Access Compliance Report

Public Rights-of-Way

Intersection ID: 8938	Main Street: NORRIS_AV	Cross Street: NEWLAND_RD	Location: NW
ADA ID: 6B1056DAA0E4	Ramp Type: Para	Initial Pass/Fail: Fail	Overall Compliance: No
		Severity Score: 1.25

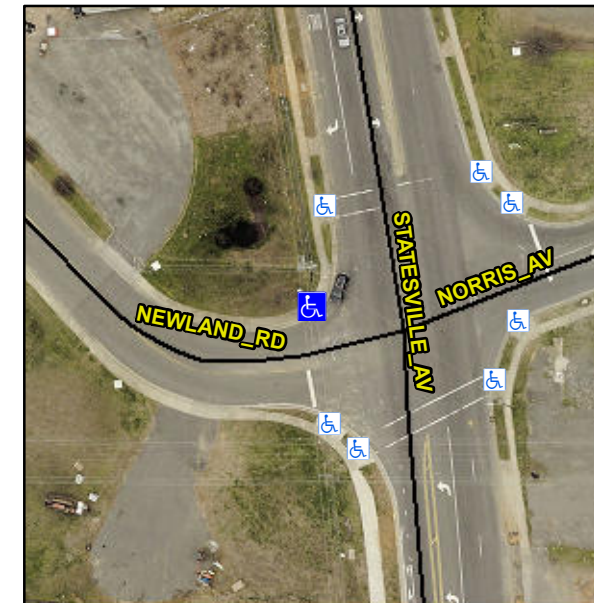
Surveyor Notes:

DAMAGED DWS

PROW/ADA:

R304.5.3

Possible Solutions:

Remove & Replace Entire Ramp.
